# Administrative Approval Action

Case File / Name: ASR-0058-2022  
DSLCL - SHEETZ AT BUFFALOE ROAD

**REQUEST:** Development of a 2.17 acre/94,717 sf tract zoned CX-3-CU and SHOD-1. A proposed retail-vehicle fuel sales w/restaurant space, Sheetz station, totaling 6,139 square feet gross floor area. The proposed building includes 4,604 sf of retail & 1,535 sf of restaurant floor space. This proposed site development is located on Lot 1 as shown on the Buffalo Bend Subdivision SUB-0075-2021 which is to be recorded.

**FINDINGS:** City Administration finds that this request, with the below conditions of approval being met, conforms to the Unified Development Ordinance. This approval is based on a preliminary plan dated June 15, 2023 by Pabst Design Group, PA.

CONCEPT  
EXTERIOR  
ELEVATIONS

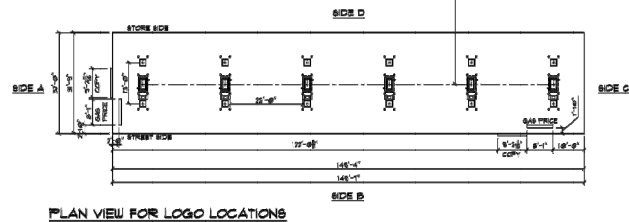
3. Elevation sheets A200, A201, for transparency, are revised for the North & East elevations renderings showing building width and sf dimensions (per the transparency data table), and the hatched portions for the window transparency areas in the 3'-8'ft range is dimensioned and demonstrate compliance with the calculations shown as well UDO Sec.1.5.9.B, Sec.3.2.5.F & the conditions in Design Alternate DA-20-2022.

4. Spot grades are updated on the elevation sheets A200, A201 for the East & North Elevations and removed on the West and South Elevations. The Post-Development 'high', 'low' spot grades should be labeled along the elevations as noted with the average # shown and also updated on sheet C4 Grading plan sheet.

5. Transpose transparency note, UDO Sec.1.5.9.B.4 and Design Alternate summary case request DA-20-2022, onto elevation sheet A200.
6. Proposed light level footcandles demonstrate compliance with UDO Sec.7.4.4.A along the proposed right-of-way line along Forestville Rd.
